Report to Planning Committee 9 May 2024

Report Summary			
Application No.	24/00150/HOUSE		
Proposal	Erection of garage with playroom/home office above		
Location	Oak House, Grassthorpe Road, Sutton On Trent, NG23 6QX		
Applicant	Mr + Mrs William Walker	Agent	Landyke Ltd - Mr David Manning
Web Link	24/00150/HOUSE Erection of garage with playroom/home office above Oak House Grassthorpe Road Sutton On Trent NG23 6QX (newark-sherwooddc.gov.uk)		
Registered	23.01.2024	Target Date	20.05.2024
Recommendation	That planning permission be REFUSED for the reasons set out in Section 10.0 of the report.

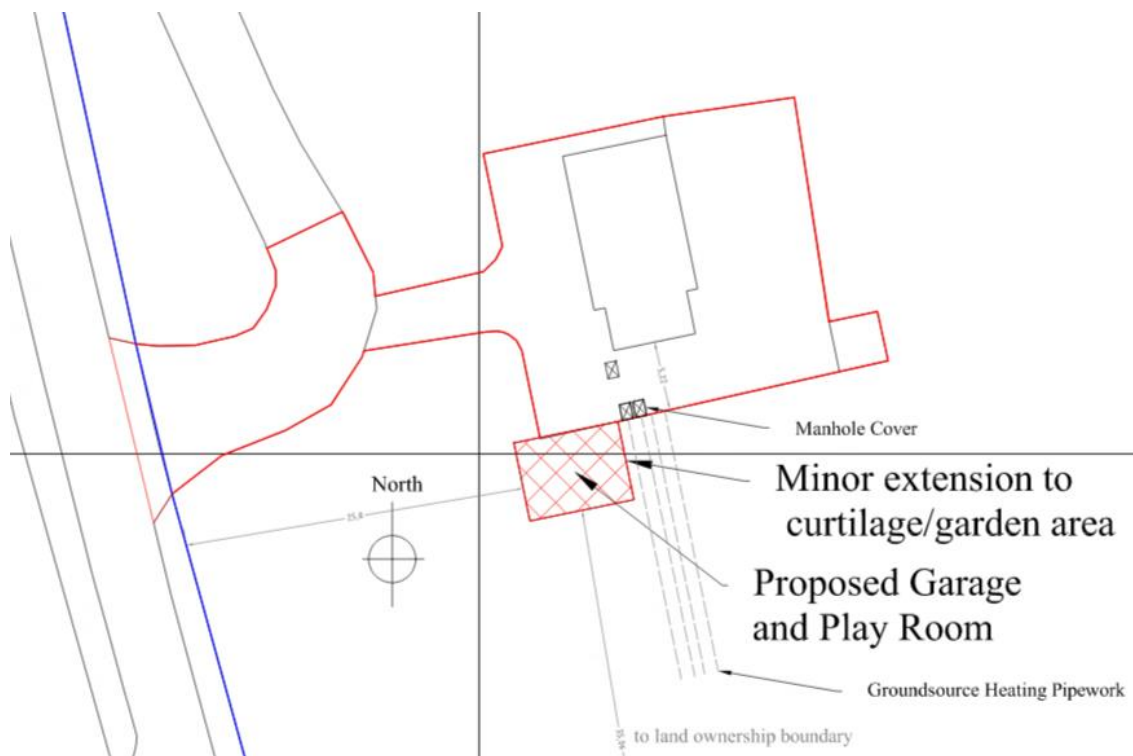
which defines the associated residential land approved to serve the dwelling. The plan below shows the land approved with the dwelling outlined in red, whereas the black line shows the existing position of the existing fence on the ground.

ground floor and playroom / home office above. The position of the proposed garage is shown shaded red on the above site plan and is shown within the associated residential land approved with the dwelling but outside the existing fencing. The building would be positioned 5.4m south of the dwelling.

- 7.13. The proposed garage and playroom/office would be located in the southwest corner of the site, forward of the principal elevation of the dwelling. It would sit predominantly outside the existing fence line, but on the land originally approved for associated residential purposes. The application states that the building would be built of brick and pantiles to match the dwelling and would have timber windows and doors which would be painted green to match the house. The building would have solar panels on the southern roof slope. Whilst the materials are considered appropriate, the scale of the garage is considered overly large and considered to dominate the host dwelling. The host dwelling itself has an eaves height of approximately 4.95m and a ridge height of 8.35m with the proposed garage and playroom/office building having eaves height of approximately 4.15m and a ridge height of approximately 5.88m. Revisions were sought to reduce the size of the building however the applicants have advised they would like to proceed with the plans submitted.

- 7.14. Whilst the proposal would not impact upon any existing hedgerows, it would be highly prominent, sited forward of the dwelling at a two-storey height. The dwelling sits in an isolated position in the middle of a large open field. The scale and siting of the proposed garage and playroom /office building would result in considerable additional built form and be highly visible within its open field context. Whilst it is noted in discussions with the agent that the building has been designed to replicate a coach house, such ancillary buildings are usually associated with high status historic buildings rather than modest agricultural workers dwellings and would instead appear as a substantial inappropriate domestic addition and an obtrusive feature that would be harmful to rural visual amenities and landscape character of this part of the open countryside. However, in relatively close proximity to the north are the complex of large agricultural buildings of Dunstall Lodge Farm and in relatively close proximity to the south are a number of two storey buildings which look more domestic in appearance to the rear of Dunstall Cottage to the south. The footprint and proximity of these buildings can be seen in the site location plan at the beginning of this report.
